# ASSESSMENT REPORT

'MANNUM WATERS' MARINA AND  
RESIDENTIAL DEVELOPMENT Proposal

**August 2008**

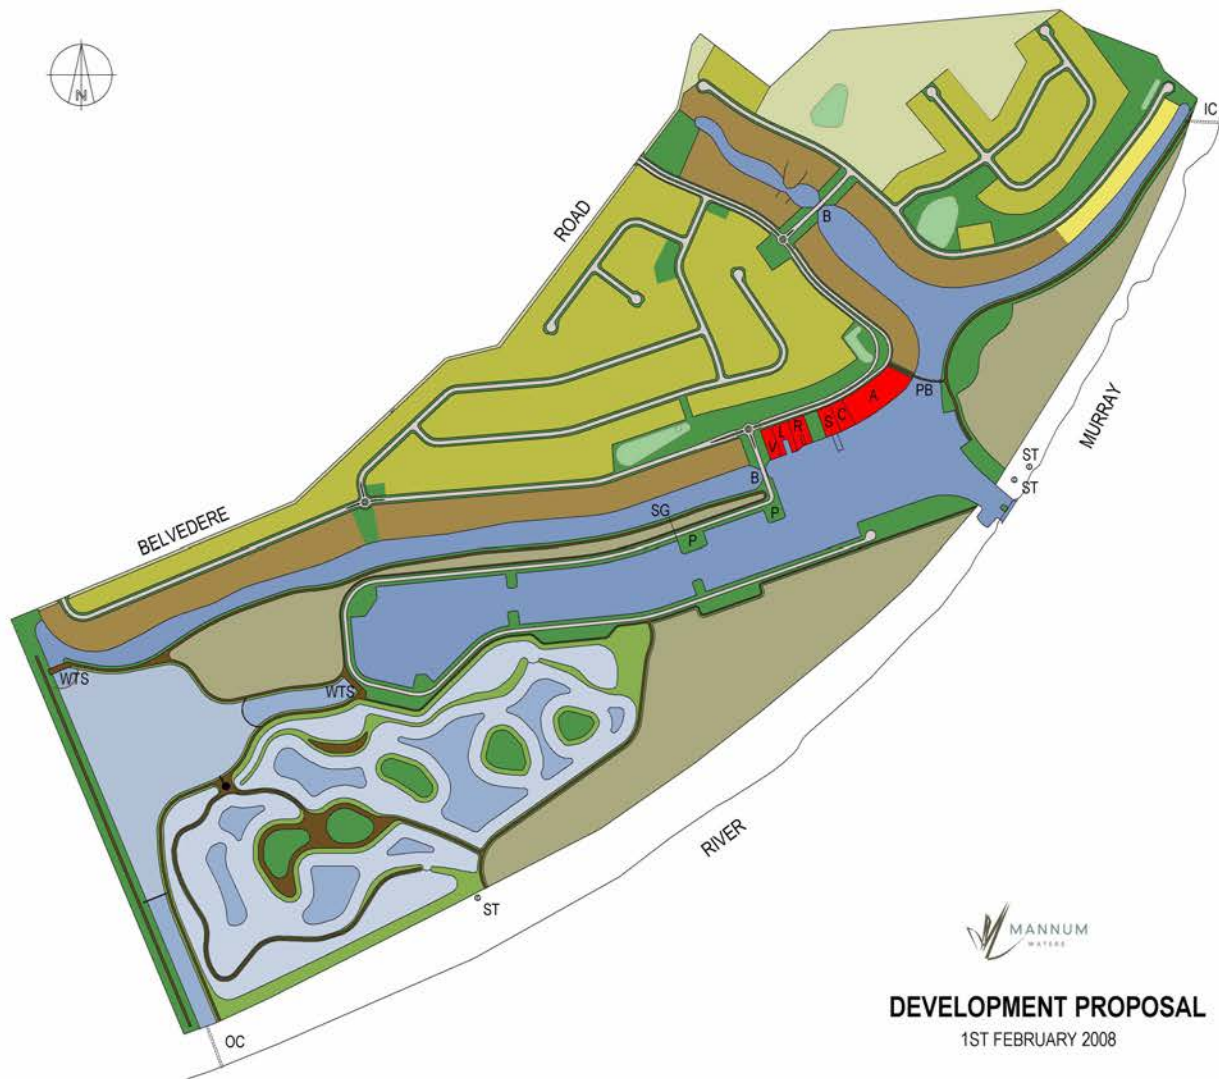
6. Further minor alterations to the road and waterway alignments have been made to ensure native trees will be retained.

Original prints and a disc with the revised layout as proposed for the development are included with this letter
